Response to Additional Information Requests

DA 21/11288

Perisher Views Ski Lodge

Geoanalysis Pty Ltd

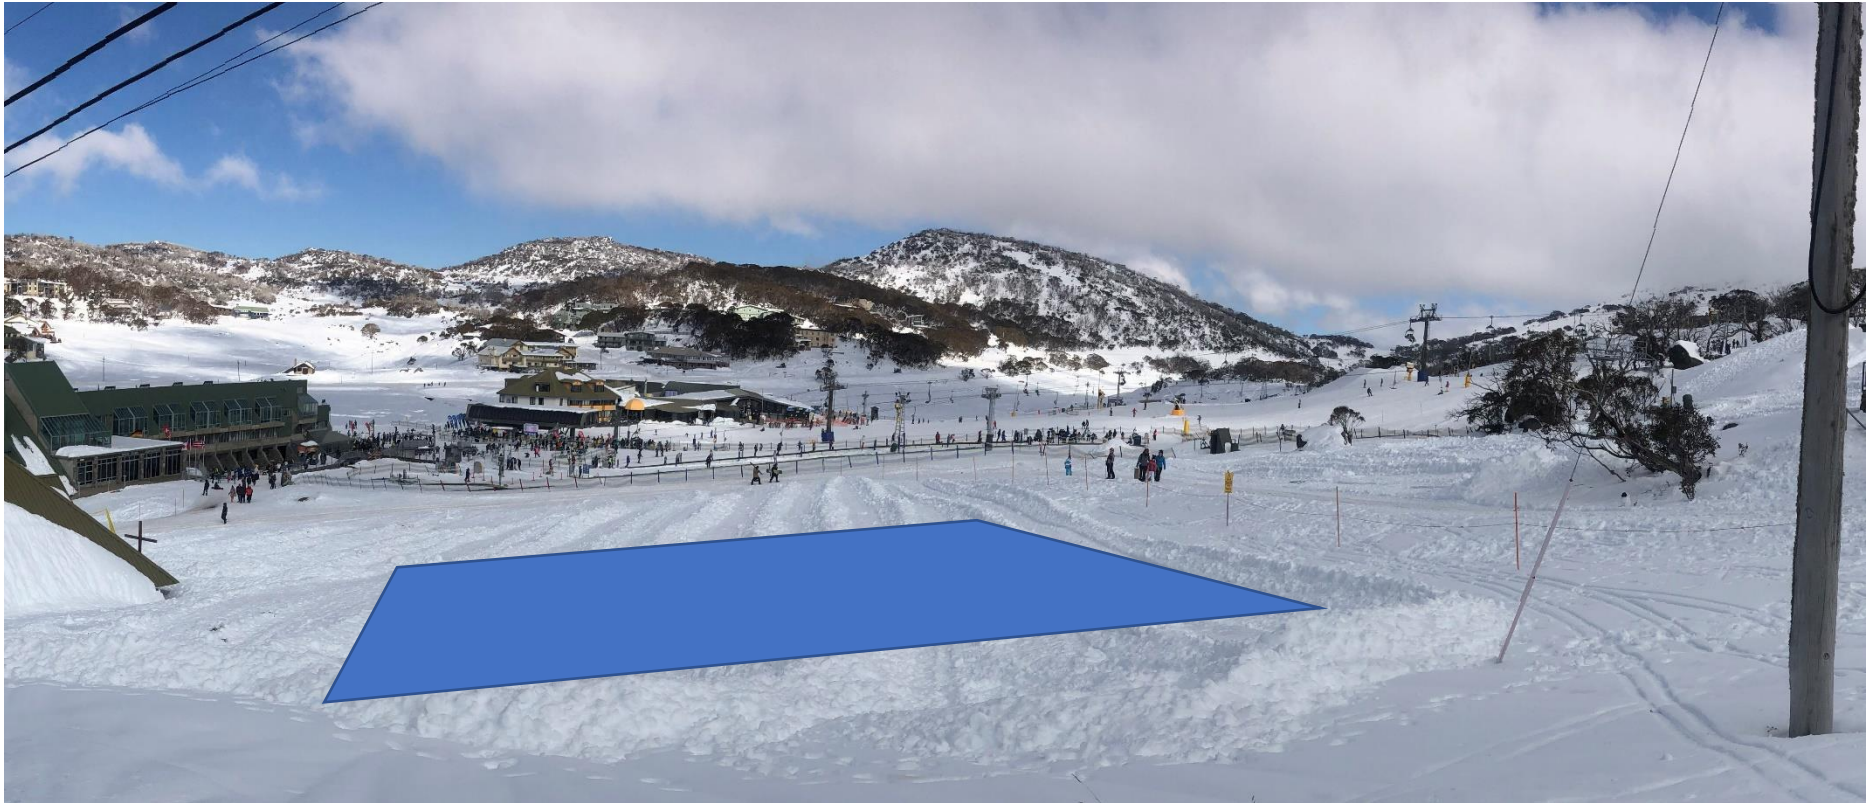
The NPWS Submission (2 September, 2021) states in relation to Burrumys Road;

'The Burrumys Road passes the leased Lot on its southern and western sides. In winter this serves as an oversnow route for access to nearby lodges, with the oversnow route intended to follow the road alignment. Accordingly, NPWS does not anticipate that the development will restrict traffic flow or endanger members of the public more than would ordinarily be the case.'

Notwithstanding the above, the proposed western deck has been removed and the building modified providing a minimum setback of 3 metres from the western boundary of the lot.

Above: KAL Submission of visual impact

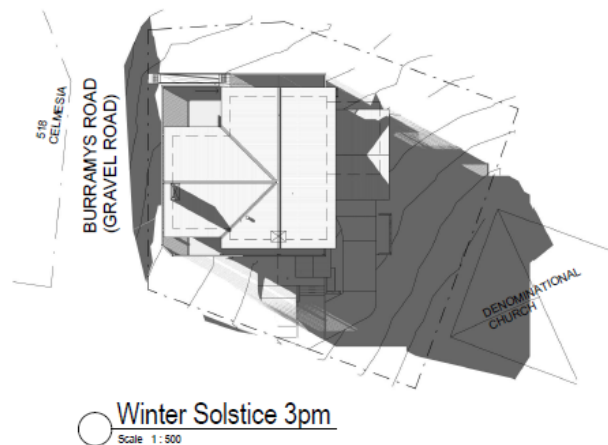
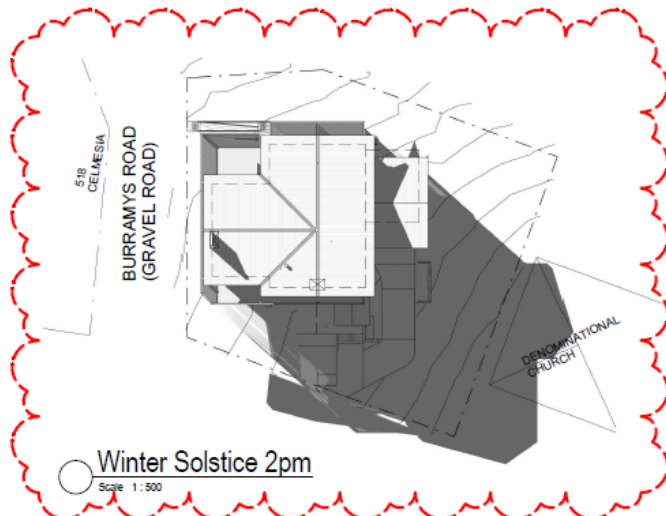
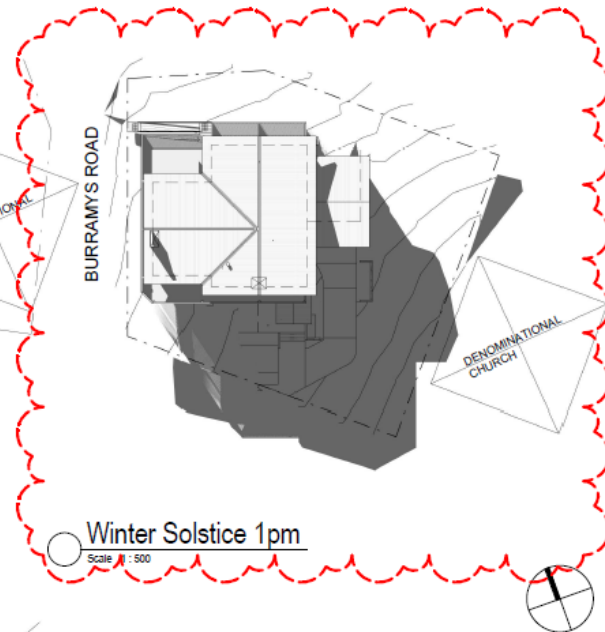
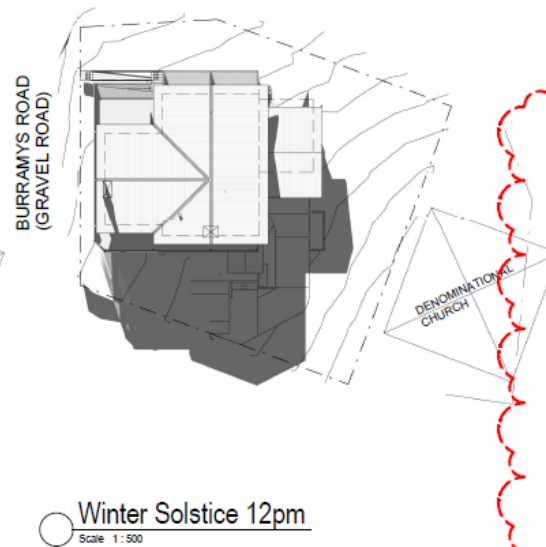
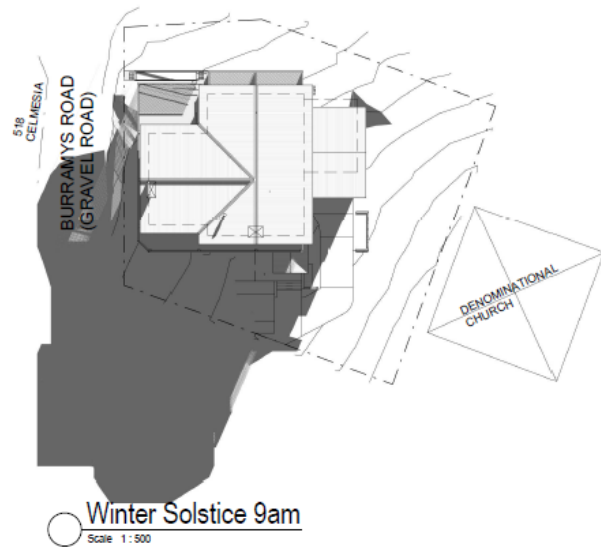
- **Inclusion of additional visual analysis from adjoining properties – photomontage of the building into the existing landscape when viewed from Ku-ring-gai and the Perisher Centre / Hotel.**

The following page compares the photo provided in the KAL submission with a 3D montage of the proposed development prepared by architects Borst and Co. The KAL submission shows the building extending to the telegraph pole and being well above the height of Burramys Road. Whereas the plans below show the closest eave and wall being located approximately 8.8m and 10m respectively southeast of the telegraph pole. The architects photomontages demonstrates that the proposed building is barely visible from KAL.

Photomontages have been prepared by Borst and Co Architects and are included in the architectural drawing plans. These images demonstrate that there will be minimal impacts on ku-ring-gai lodge and the building form is consistent in scale and architecture to existing structures.

Significant effort has been put into minimising impacts on the views to KAL including recessing the north-western corner of the building, whilst also maximising the setbacks from the Alpine Church. As shown on the following page the proposed lodge will not impact on the views to Mount Perisher from KALs kitchen window, is located behind tree and will be barely visible.

DA_11A

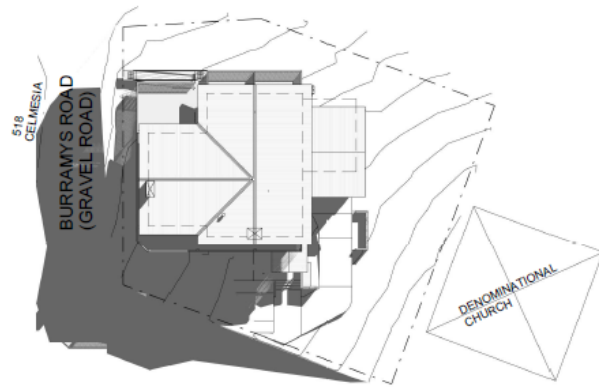
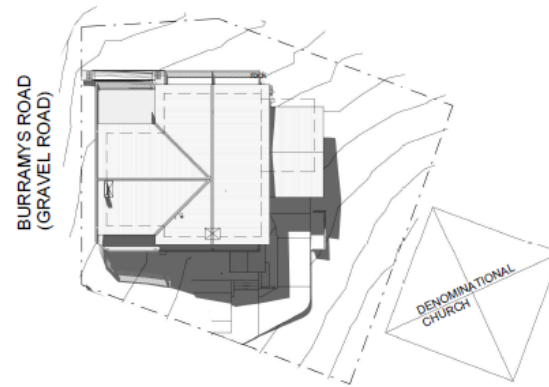
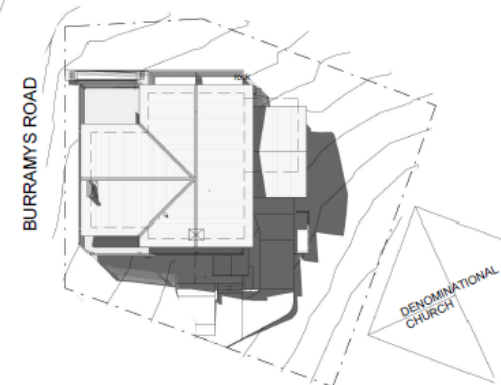
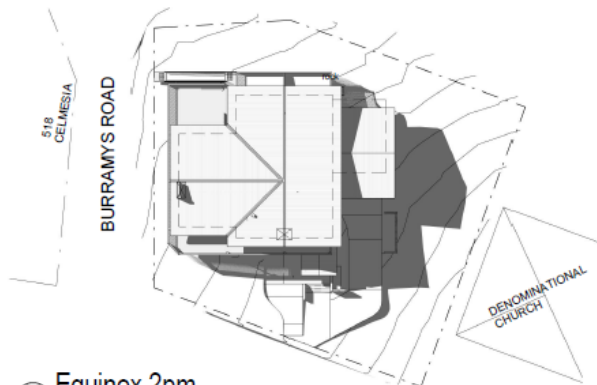
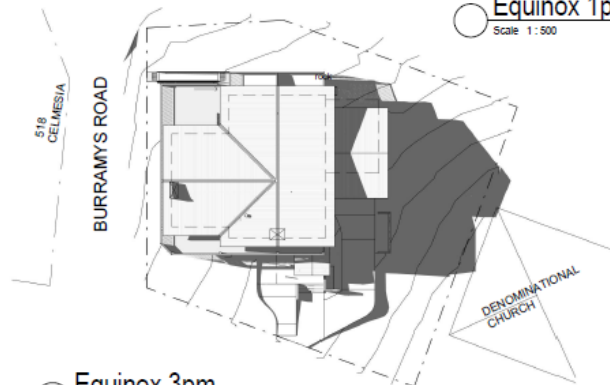
- **Solar access diagrams indicating 1pm and 2pm shadows from the building. In addition, submission of September 21 shadows from the building for the Department to consider impacts upon the adjoining Alpine Church.**

These have been prepared and are included in the updated architectural drawings.

The winter solstice occurs early in the season (typically around the 22nd June) and overshadowing of the church commences at approximately 1pm, occurring later in the day each day thereafter. Church services occur from 12.30 to 1pm every Sunday. The spring equinox occurs later in the season (around 22nd September) and overshadowing at this later stage of the season starts after 3pm (shadow diagrams are provided on the following pages). Three (3) hours of sun on the solstice is a common planning standard in NSW, with the sun rising before 8am on the solstice the church would receive in excess of 5 hours of sun.
